Re: Margaret O'Brien Drain

Attached is a petition and plans for the proposed relocation of the Margaret O'Brien Drain. The relocation is being proposed by Sand Key Properties, LLC. The proposal is to reconstruct the open drain in place on parcel 14-14-12-00-00-005.000 as part of the Stoepelwerth & Associates Office Building project as shown on Sheet C201 of plans prepared by Stoepelwerth & Associates, Job Number 51000 last revision date May 25, 2005.

**Re: Margaret O'brien Drain: Sand Key Properties Reconstruction**

# RECORD DRAWING

SHEET NO.  
C201

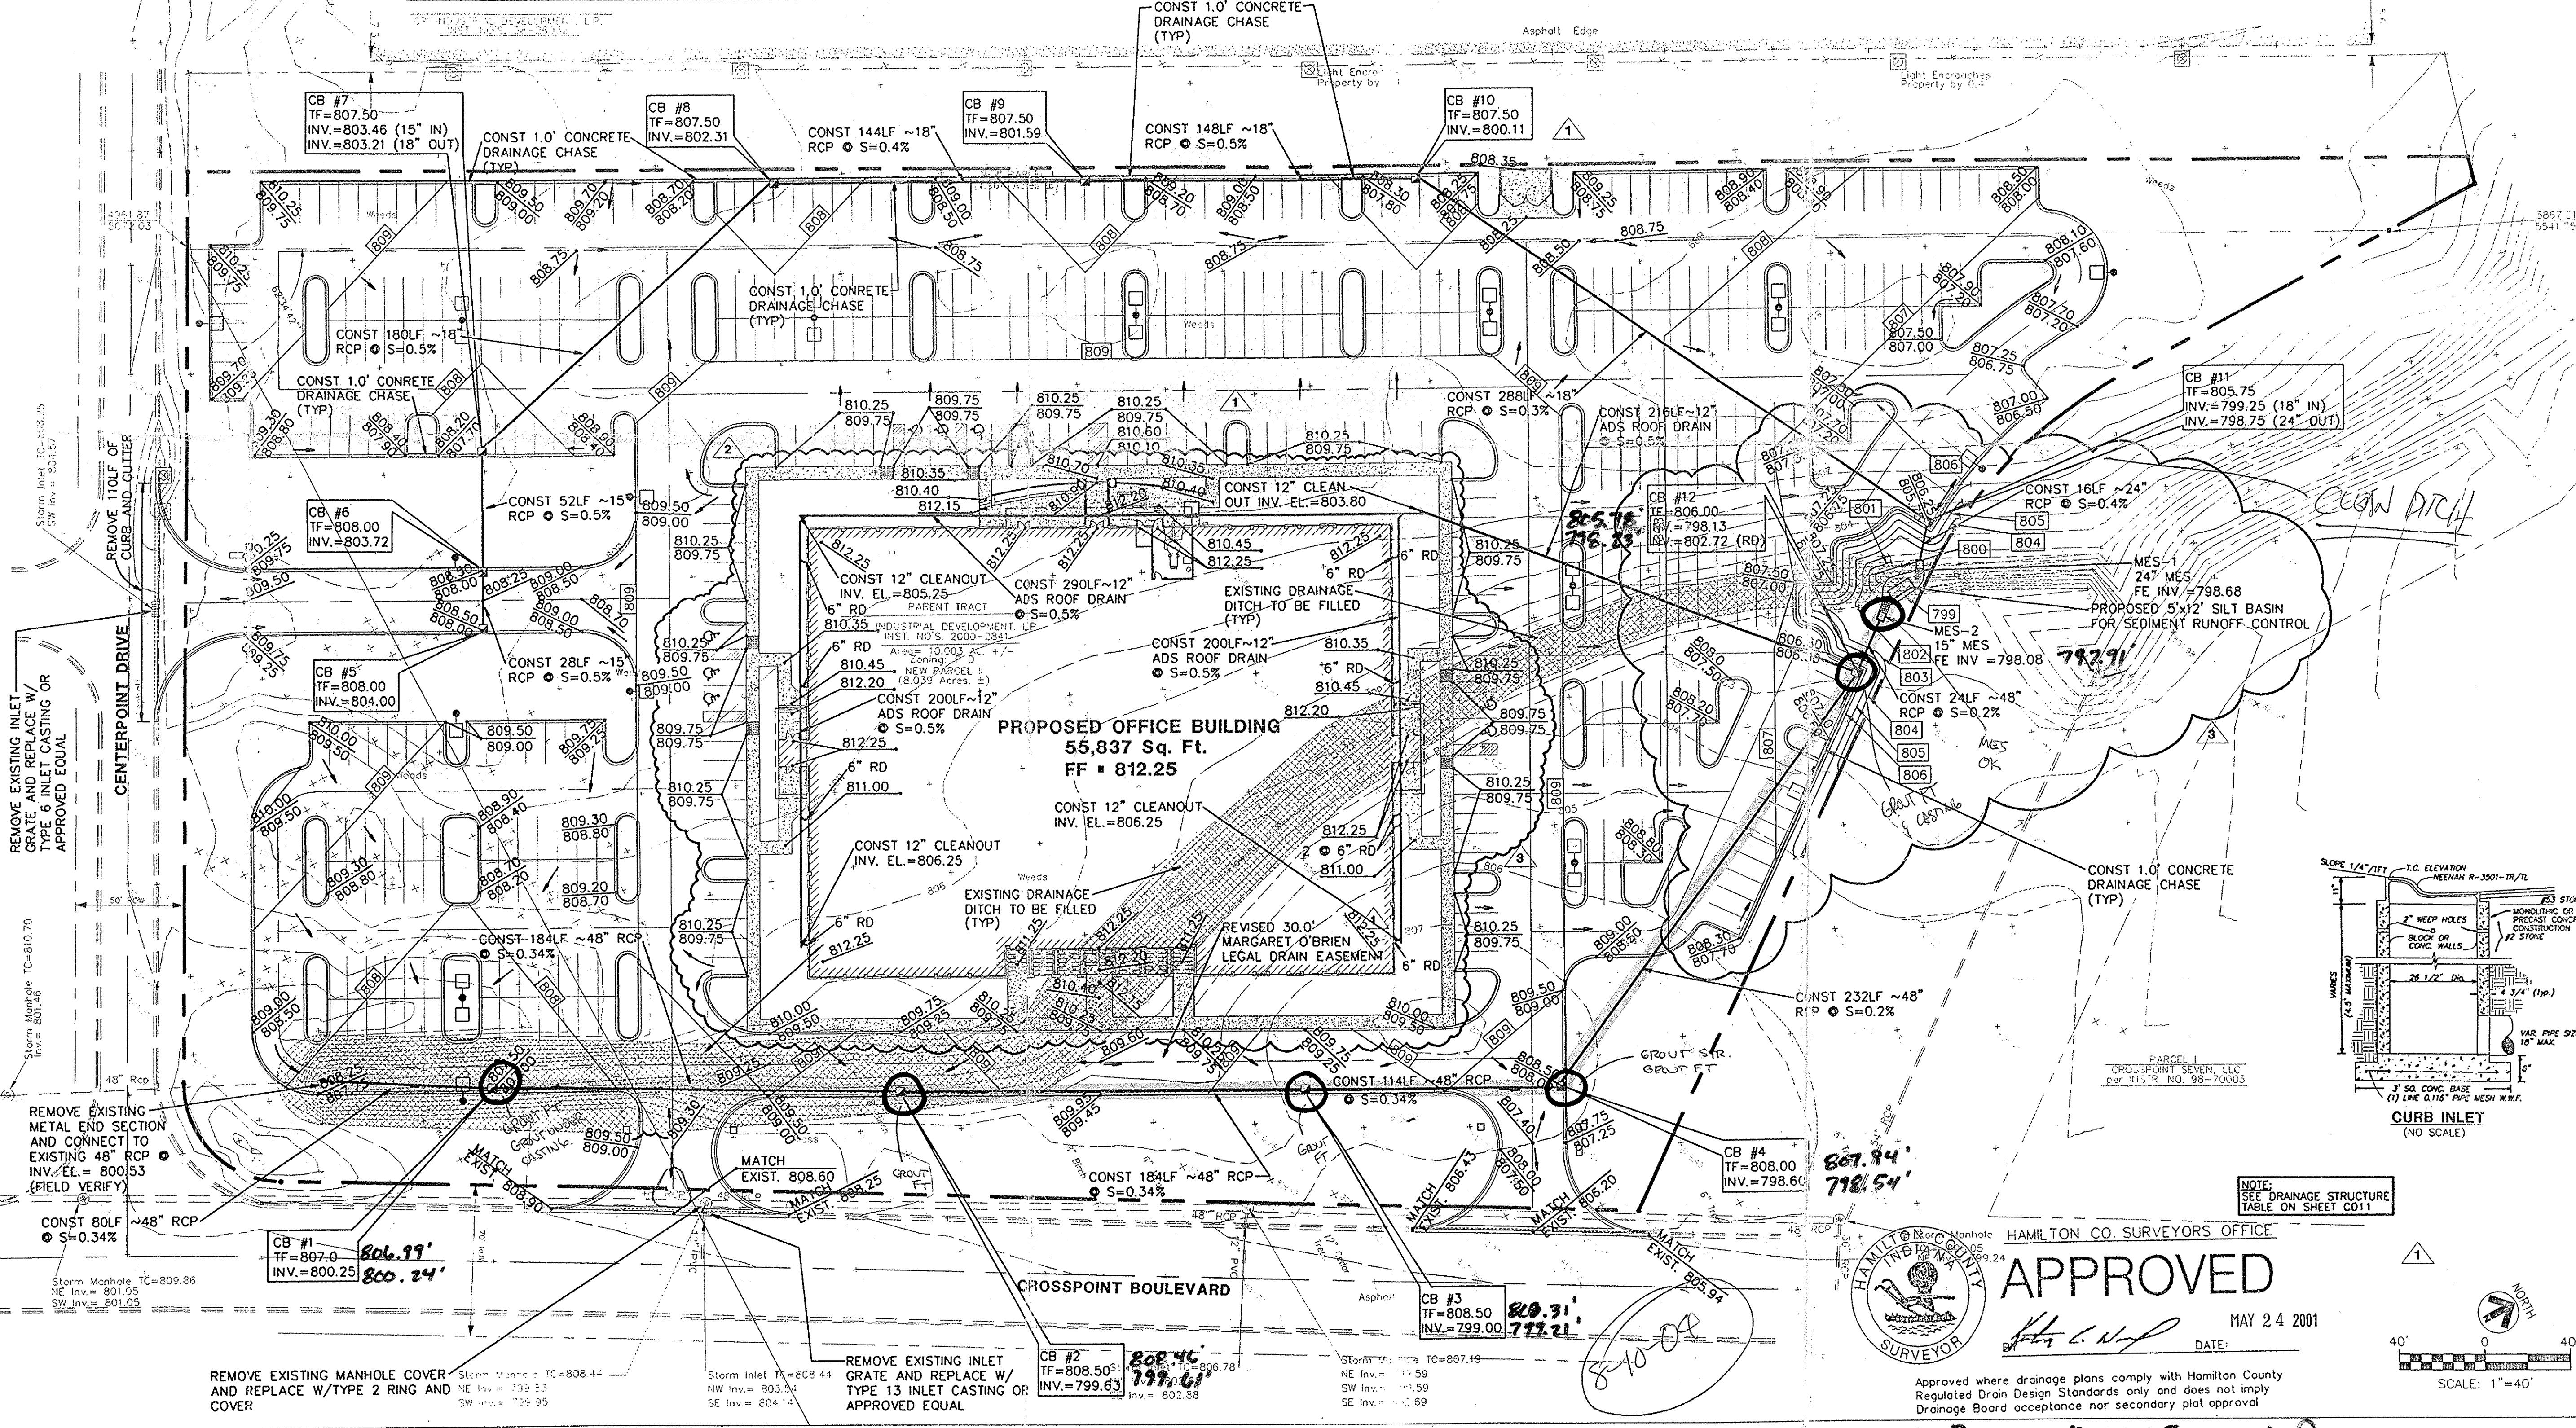
During construction, changes were made to the drain, which will alter the plans submitted with my report for this drain-dated December 7, 2005. The report was approved by the Board at the hearing held December 22, 2005. (See Drainage Board Minutes Book 8, Page 568)  
The changes are as follows:

The amount of open ditch enclosed with dual 36" RCP was lengthened from 11 feet to 12 feet. Nonetheless, the drain itself was reconstructed in place. Thus, the total length of drain reconstructed remains at 114 feet. Therefore, the length of the drain due to the changes described above remains at **0 feet**.
